MFN 07-439

Subject: **Response to Portion of NRC Request for Additional Information  
Letter No. 85 - Decay Heat Analysis - RAI Number 6.3-62**

**RAI Number 6.3-62**

Figure 6.3-62-1 (DCD Tier 2, Figure 6.2-8c)

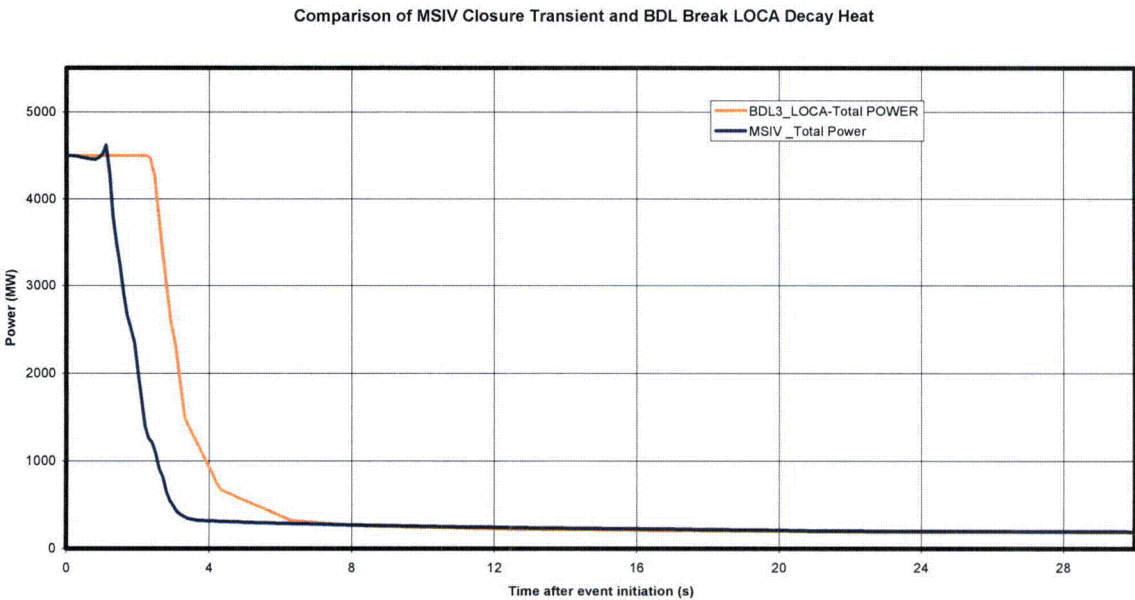
- (B) A justification of the application of the same decay heat curve to both small and large break LOCAs. Particularly, provide an analysis demonstrating that the assumptions used to calculate the fission power during rod insertion and fission power from delayed neutrons are conservative for a full spectrum of LOCAs. If a TRACG analysis is used to demonstrate the conservatism, fully describe the calculation; including the specific decay heat option used, the initiator for the SCRAM signal, the evolution of the core average void fraction, and any assumptions regarding blade insertion time or axial load.*

Figure 6.3-62-1 (DCD Figure 6.2-8c) "Comparison of MSIV Closure Transient and BDL Break LOCA Decay Heat" shows that during both the early high energy gradient and later stages of these events, the decay heat power from the BDL small break LOCA (DCD Tier 2, Revision 3, Subsection 6.2.1.1.3.3) is higher than the one from the MSIV closure transient at EOC (DCD Tier 2, Revision 3, Subsection 15.2.2.7), except for a small time where the MSIV closure transient at EOC decay heat is (about 3%) above the nominal power for about 0.2 seconds (between 1 to 1.2 seconds into the event). Even though the decay heat from the MSIV closure transient at EOC event is slightly higher for a very short time, the contribution from this small peak to total power is shown to be negligible when compared to the time-integrated power for both events (as seen in Figure 6.3-62-2 and Figure 6.3-62-3). Furthermore, the pressure increase due to the MSIV closure transient at EOC and its positive reactivity insertion impact is neutralized by the negative reactivity

from the control rod insertion. The impact on power from the negative void feedback during a BDL small break LOCA is greater than the one caused by the MSIV closure transient at EOC, because the transient event involves more limiting conditions that promote a smaller negative void feedback or none at all. Therefore, based on the behavior shown in the above comparison, it is demonstrated that the same decay heat values are applicable to the LOCA spectrum events identified in DCD Tier 2, Revision 3.

DCD Tier 2, Figure 6.2-8c will be revised consistent with Figure 6.3-62-1 in this response. DCD Tier 2, Subsection 6.2.1.1.3 will be revised to add the text shown in the attached markup.
